TWELVE MILE TOWNES

PLANNING REVIEW

JSP 25-03 TWEVE MILE TOWNES		
Preliminary Site Plan, Special Land Use with Planned Development-2 (2 nd Revision)		
Date of Review	June 09, 2025	
Plan Date	May 07, 2025	
Applicant	Singh Development LLC	
Parcel ID's	Section 14: 22-14-200-034, 22-14-100-038 & -039	
Site Size	16.37 acres gross, 15.05-acre net	
Site Location	South of Twelve Mile Road and east of Novi Road, located on both the east and west sides of the Twelve Oaks Mall access drive	
Site School District	Novi Community School District	
Current Site Zoning	RC Regional Center with Planned Development (PD-2) Option	
Adjoining Zoning	North	OS-1 Office Service & RA Residential Acreage
	East	RC Regional Center
	West	RC Regional Center
	South	RM-1 Low Density Multifamily Residential
Current Site Use	Vacant	
Adjoining Uses	North	Medical Offices, Story Point Assisted Living & MSU Tollgate Farm
	East	Medical Office
	West	Fast-food Restaurant (McDonalds)
	South	Twelve Oaks Mall & Assisted Living Facility (Walton Wood)

Figure 1. City of Novi Regulated Woodlands Map

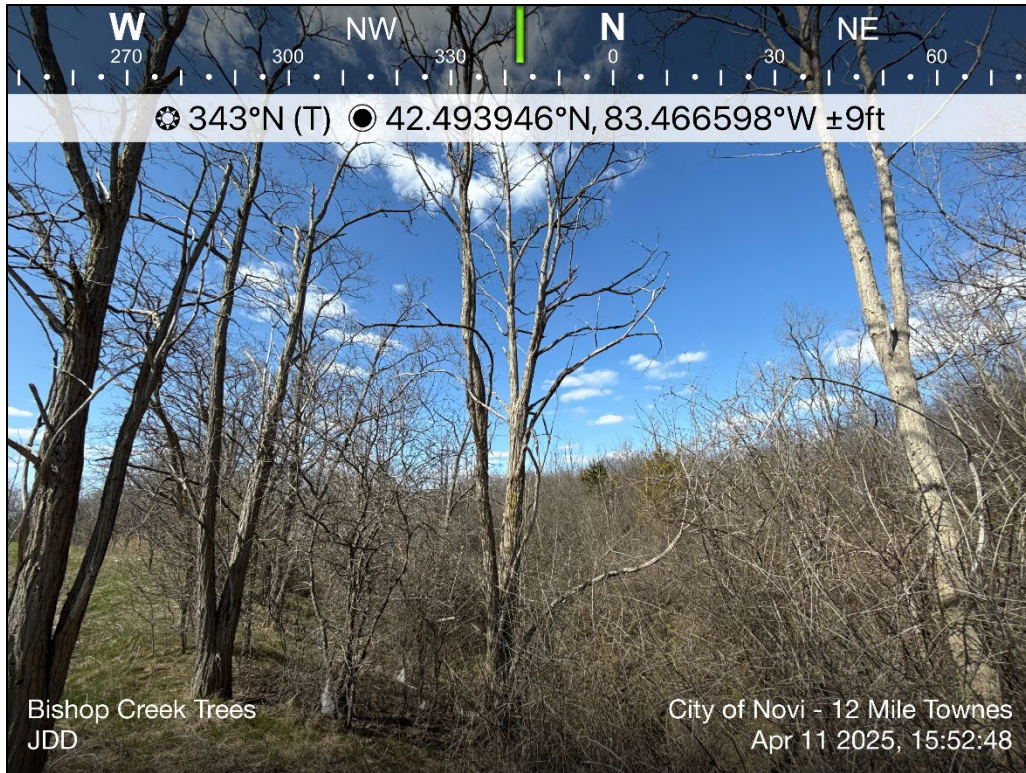
- Although no tree replacements are required on-site, it is recommended that remaining shrub and tree covered areas (identified on **Figure 1**) be preserved in a conservation easement for both woodlands and wetlands. If feasible, this will allow for the permanent shade cover of Bishop Creek (reducing water temperature) and continued growth of trees in this area. This may or may not benefit the proposed development in the form of additional future visual and sound screening between the existing 12 Oaks Mall and the proposed development.

Figure 1. City of Novi Regulated Wetlands Map
Approximate Site boundary is shown in red.
(Approximate) Regulated Wetland areas are shown in blue.

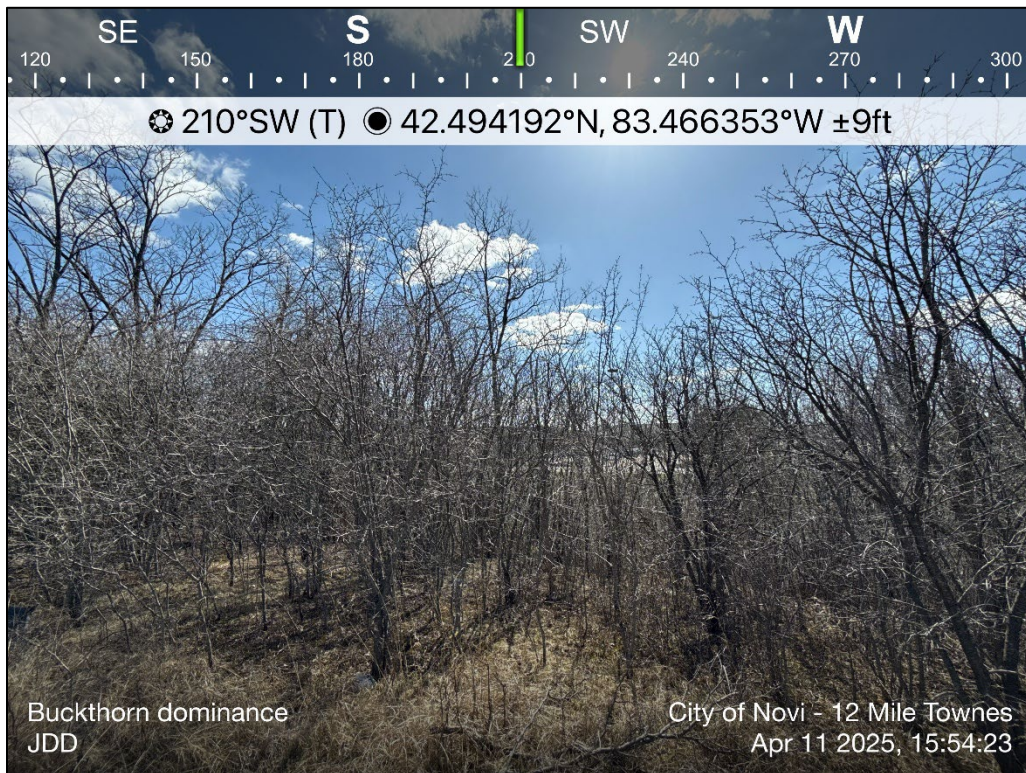
- **Requested Edit:** The applicant should list the type (Cowardin classification) of wetland on the site plan (Sheet C9). Additionally, the applicant should list the amount of fill to be placed in each wetland. It should be noted that the remaining undisturbed portions of Wetland B and Wetland A may need to be marked with signs noting that no mowing or disturbance will be allowed after the development is established (if approved) to notify future land owners of the protection needed around these areas.
2. An existing culvert/wetland crossing was identified in the northwest portion of Wetland Large. To reduce any unnecessary impacts to the wetland, the applicant should add the existing culvert/crossing to the plan and adjust the size of the wetland, if necessary. Photographs of the area are included in **Attachment B**.
